Access Compliance Report

Public Rights-of-Way

(Curb Ramps)

Intersection ID: 10037210	Main Street: SANDY_ROCK_PL	Cross Street: N/A	Location: E
ADA ID: A27E9F0C4C61	Ramp Type: Perp	Initial Pass/Fail: Pass	Overall Compliance: No
Severity Score: 2.5			
Codes/Mitigation Info/Possible Solution		Field Measurements/Component Compliance

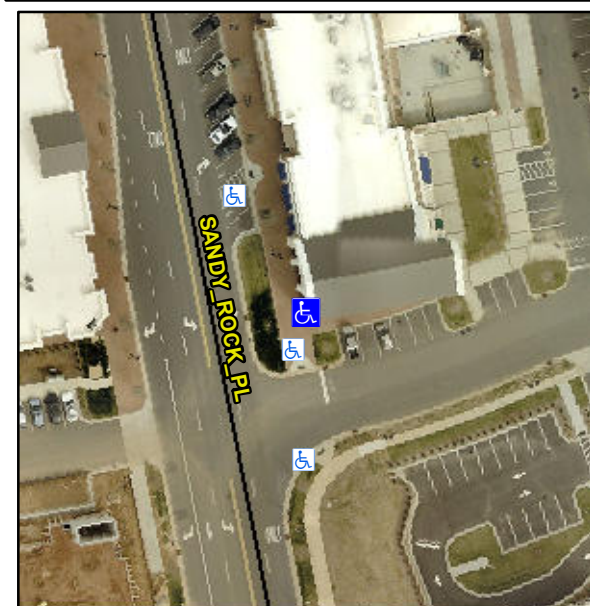
Not Found, R304.5.3, R304.2.3

Compliance	Description	Data	Compliance	Description	Data
N/A	Ramp Length (in)	77.0	Yes	Ramp Slope (%)	7.6
Yes	Ramp Width (in)	60.0	Yes	Ramp XSlope (%)	0.8
N/A	Flare Type LT	Sloped	N/A	Flare Type RT	N/A
N/A	Flare Slope LT (%)	6.7	No	Flare Slope RT (%)	10.1
N/A	Flare Traversable LT?	Yes	N/A	Flare Traversable RT?	Yes
Yes	Landing Length (in)	60.0	Yes	DWS Provided?	Yes
Yes	Landing Width (in)	60.0	Yes	DWS Contrast?	Yes
Yes	Landing Slope (%)	0.1	Yes	DWS Length (in)	24.5
No	Landing X Slope (%)	3.1	Yes	DWS Full Width?	Yes
N/A	Landing Curb? (Y/N)	No	Yes	DWS Offset (in)	0.0
N/A	Shared Landing?	No			
Yes	Gutter Ponding?	No	Yes	Gutter Slope (%)	5.0
Yes	Gutter Lip Ht (in)	0.0	Yes	Gutter X Slope (%)	1.0
N/A	Painted X Walk1?	No	N/A	Painted X Walk2?	N/A
	X Walk 1 Direction	To W		X Walk 2 Direction	N/A
N/A	X Walk 1 Width (in)	N/A	N/A	X Walk 2 Width (in)	N/A
	X Walk 1 Slope (%)	1.7		X Walk 2 Slope (%)	N/A
	X Walk 1 X Slope (%)	1.6		X Walk 2 X Slope (%)	N/A

Remove & Replace Entire Ramp.
